**SANDOVAL COUNTY
REGIONAL ANIMAL RESOURCE CENTER
VISTA SANDIA COURT
Bernalillo, New Mexico 87004**

**ADDENDUM NO. 01
FY26 - SCPW - 07**

November 17, 2025

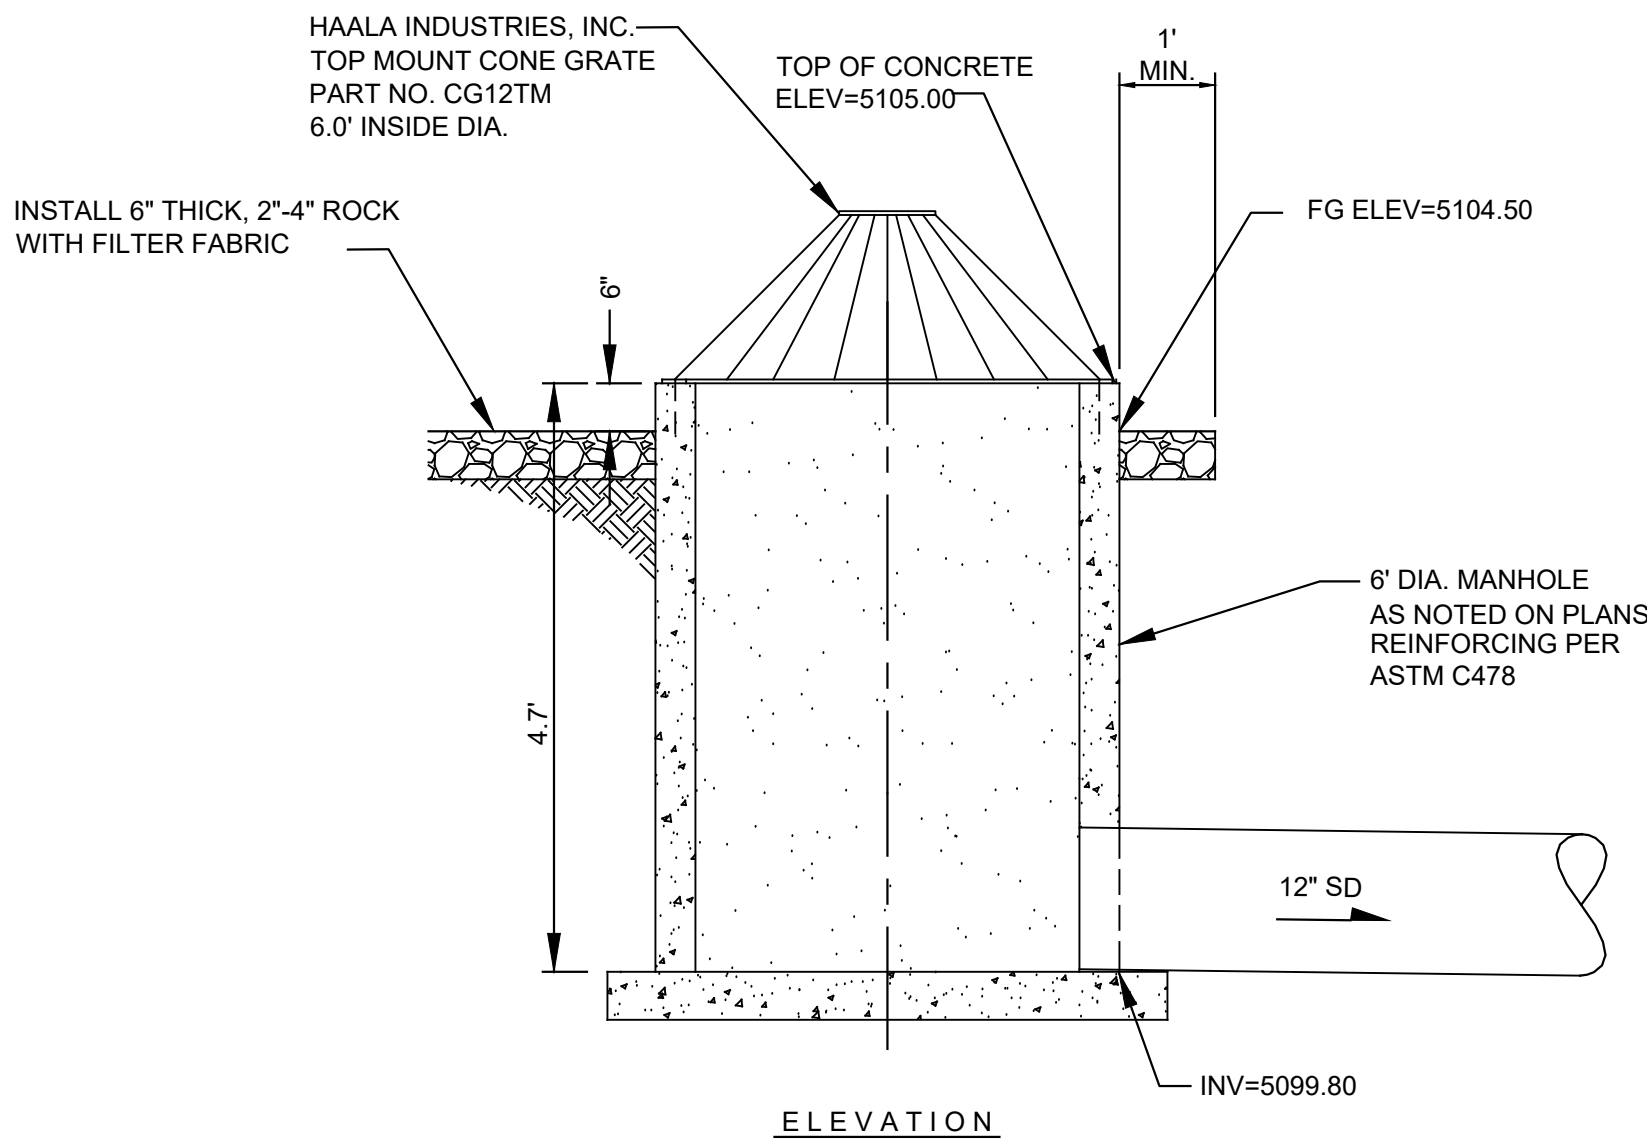
61. Sheet C507 detail B calls for a 4” perforated drain tile and to see plans for piping, please indicate what plans this piping is shown on.
Response: Piping sizes are called out on Sheet C-101.
